From: Marge Schmuckal
To: Daniel L. Cummings; Mary Costigan
Date: 7/14/2009 10:29:35 AM
Subject: RE: RE: 38 Torrington

38 Torrington, PI

Re: 38 Torrington Avenue

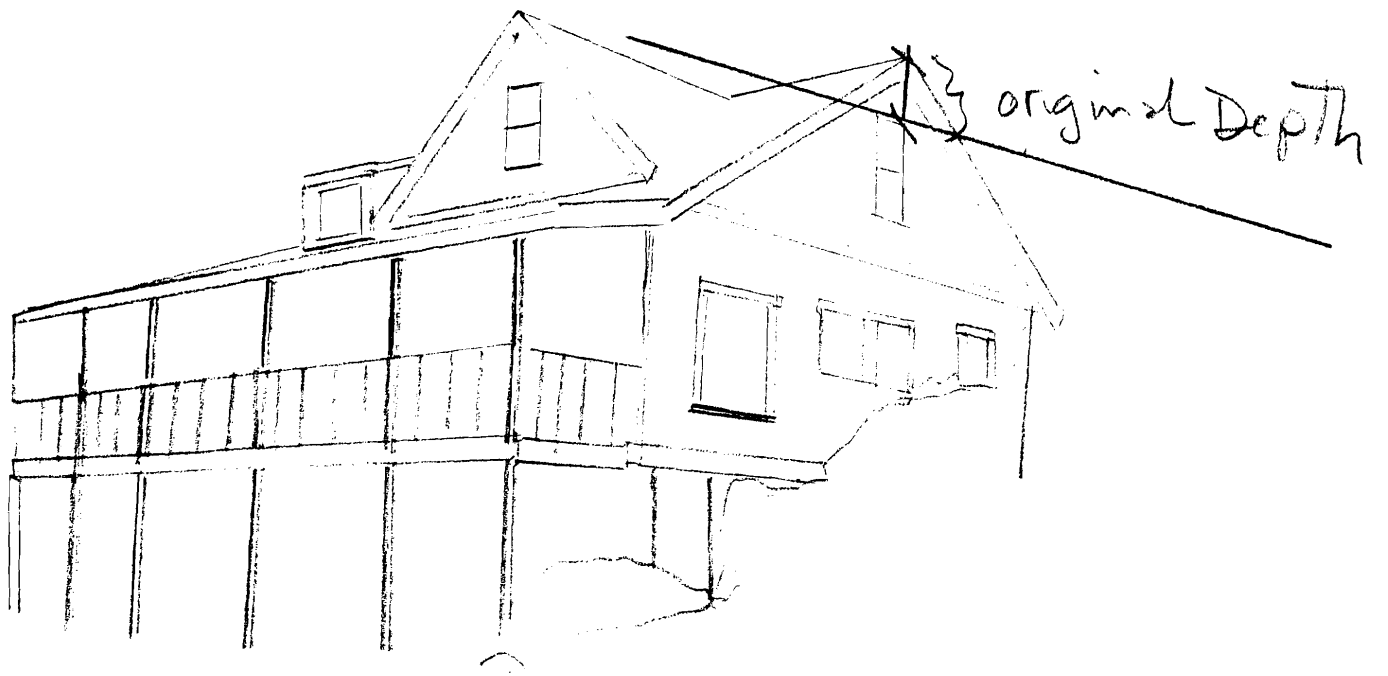
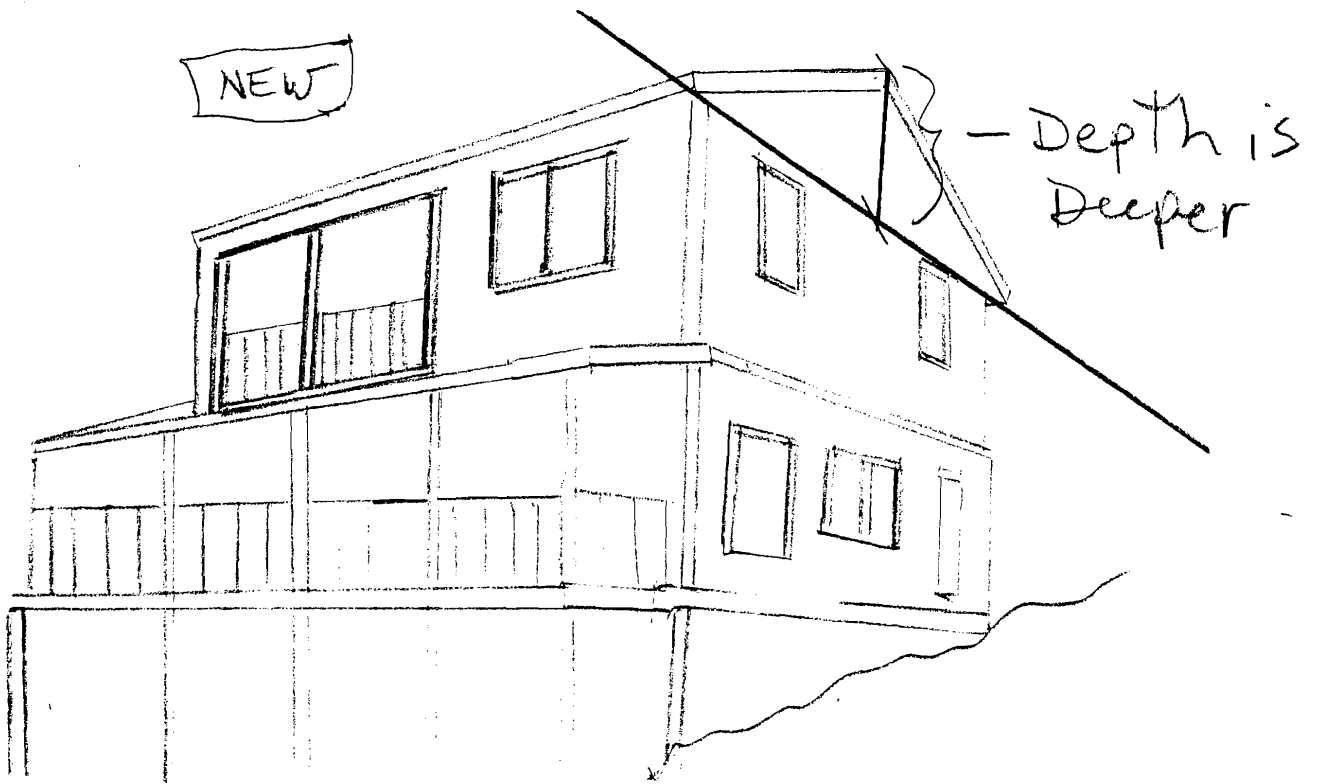
I have reviewed what you e-mailed me. Perhaps I was not clear in my description. There are two items that stand out in the construction that do not meet the test of "maintaining the same roof configuration". I do note the difference in the pitch of the original roof and the new roof. But there is also a change in the depth of the roof as measured from the ridge downward.

The original roof was incorporated into the habitable space with very little depth from the ceiling to the ridge. In the new construction a full truss system was placed ontop of the new fully dormered area. That construction is significantly different. I did sit down with Bill Childs to explain this. There are different building techniques to resolve this problem, such as the use of scissor trusses. It would reduce the depth of the height of the new roof structure.

You conclude that the new roof pitch changed in a way that increased the pitch and thus created a "taller depth." The fact is, as seen below, the roof pitch did change slightly, but it was a change the other way, i.e., the roof pitch decreased from 6/12 to 5/12. The result was that the roof configuration has slightly less depth, not more, than the original.

Marge,
I received the copy of your decision. I believe you may have misinterpreted some of the information I sent you. We reduced the pitch from a 6/12 to a 5/12; mathematically it is not possible to create "a taller depth from the bottom cord to the top of the peak" in this instance. I believe we may want to address this sooner rather than later in the hopes of (a) The members of the ZBA having correct information and (b) the interested parties coming to some kind of resolution to end the seemingly limitless appeals. I am at your disposal to discuss for the rest of the day, just call.
Regards,
Bill

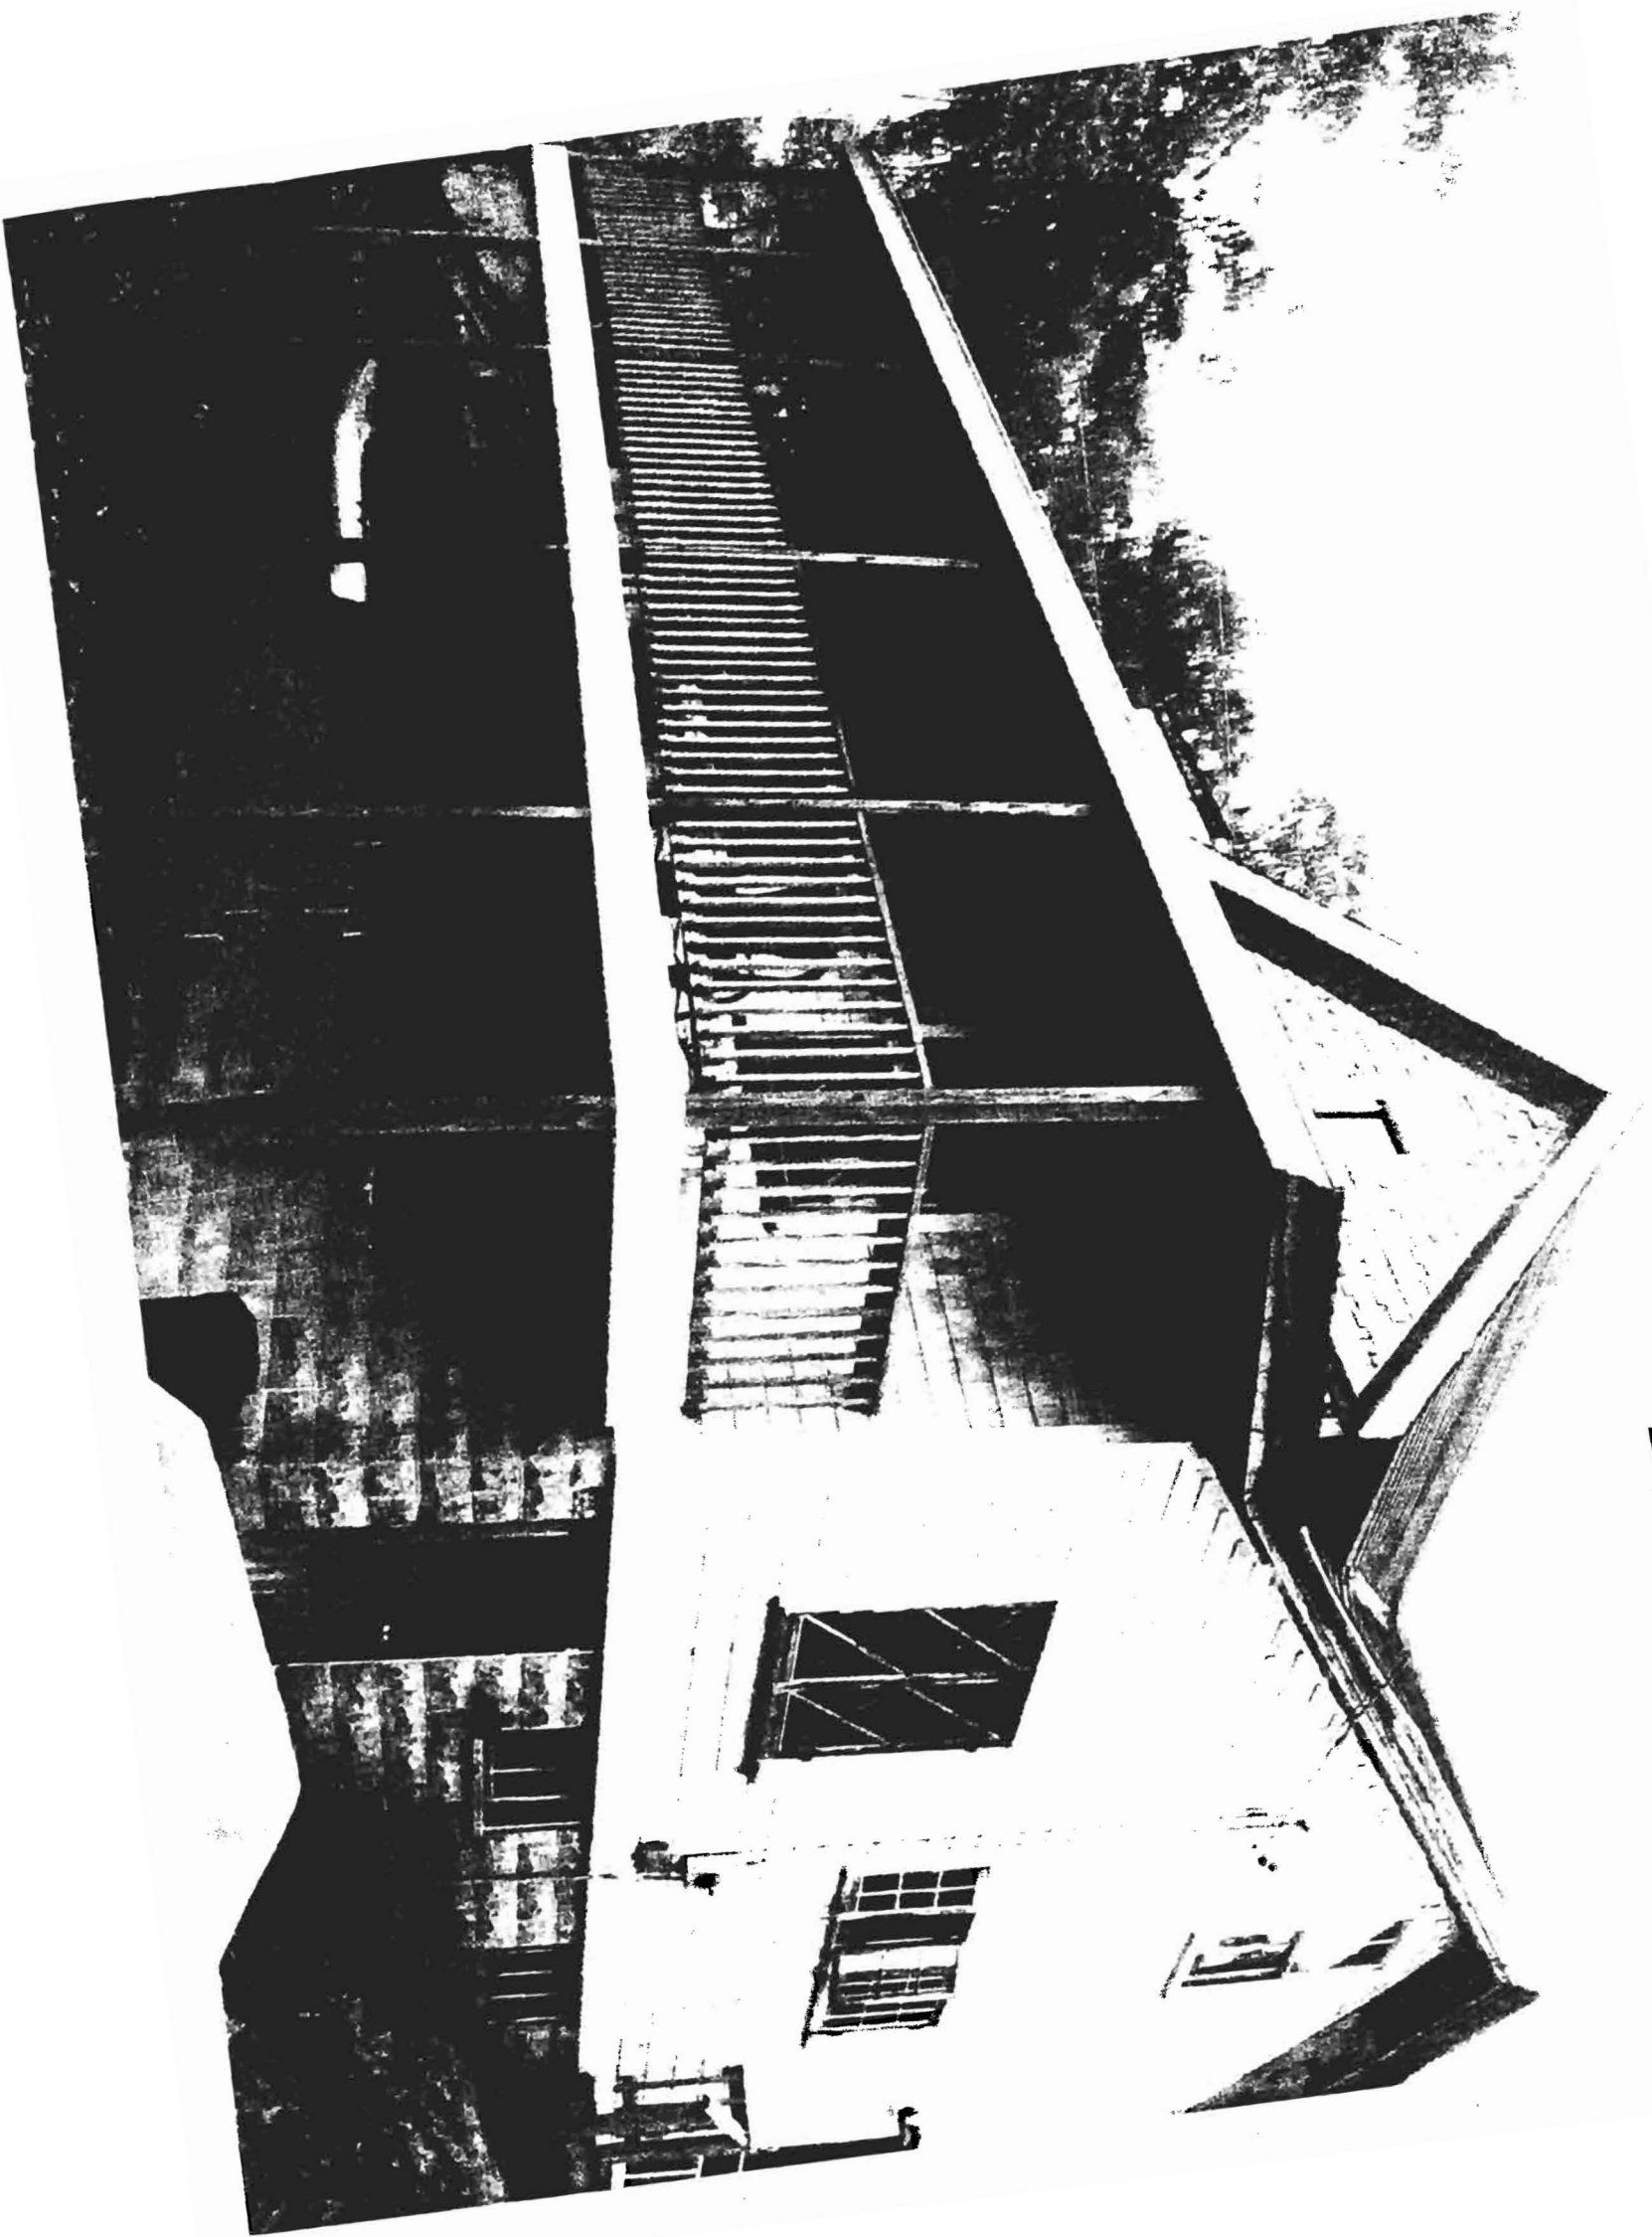
Attached is my attempt to clarify my most recent memo - I am seeing that the roof pitch and the ^{new} roof (i.e. the "Depth" of it) do not meet the ordinance in regards to keeping the original "roof configuration". I hope it helps. I traced from photos. It is the concept that I am trying to convey - Don't judge my art work
